NuLu
Review Overlay District
Report of the Urban Design Administrator to
the Committee

Case No: 17COA1108
Classification: Non-Expedited

Property Address: 900, 906, 914 E. Main Street

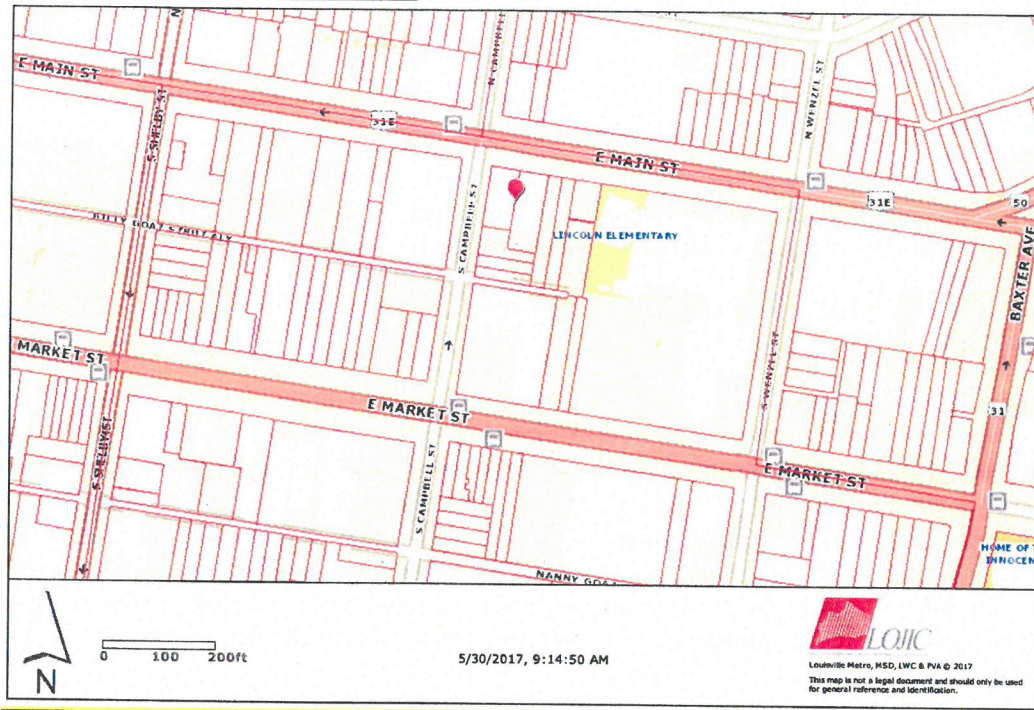
Along the **North Façade**, the exterior masonry will be scraped of existing paint and be repainted. The existing storefront along East Main Street will be restored; wooden storefront system is to be replaced. Existing downspout, soffit, and gutter systems will be replaced. A new roof deck and elevator shaft will be installed. The existing signs will be painted over.
